12_20 Critical Driveway Linestyles Update

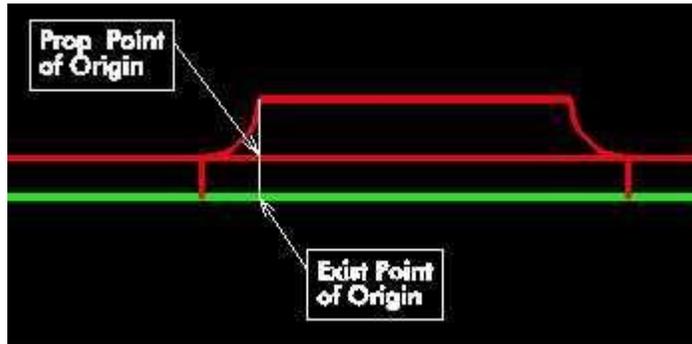
My driveway isn't lining up correctly with the C&G and to deduct the driveway from the C&G length, it needs the driveway to be on the curb and gutter line

We have moved the point of origin for both driveway linestyles from the proposed EOP line to the Curb and Gutter line. See sketch below.

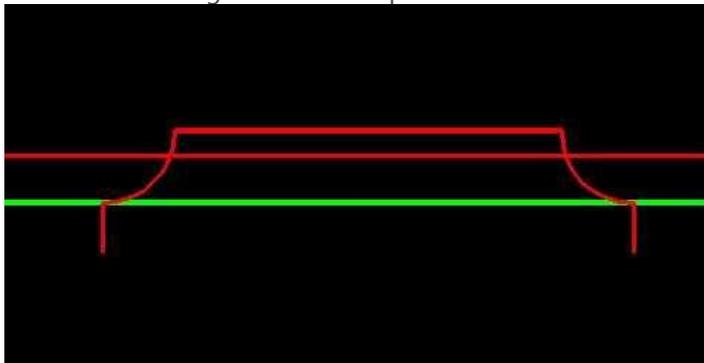
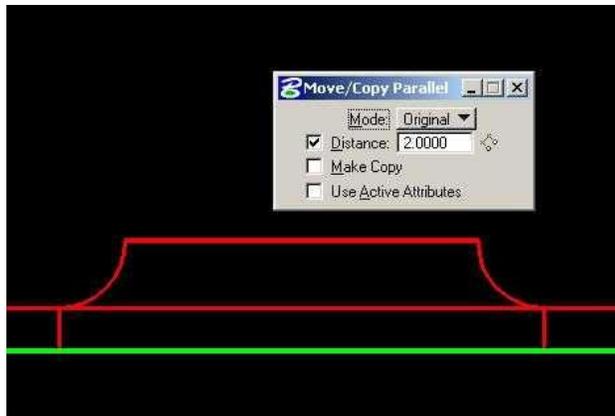
All previous placed concrete drop and radius type driveway linestyles are to be moved from the green prop EOP line to the red curb and gutter line. See pictures below.

Since these driveways are linestyle line elements, the move parallel tool at a distance of the gutter width seems to be the best way to accomplish this.
